# Site Supervisor

## Update Advisory Site Supervisor 2.16F02

Table 1: Site Supervisor 2.16F02 Feature and Fix Matrix

**Control Inventory**

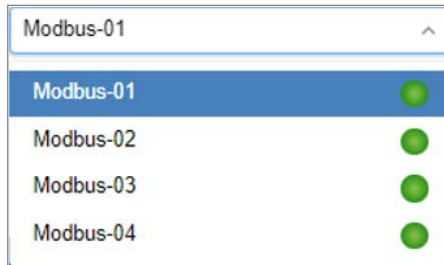
- A COM Port bandwidth calculator has been integrated into the Control Inventory. In the drop-down list of the Port ID column, a color indicator has been added for the bandwidth condition.

Condition	Notes / Warning	Color Code
Good	No warning	Green
Notice	Bandwidth usage is high	Yellow
Alert	Controllers will exceed available bandwidth for this route, consider using another port.	Red
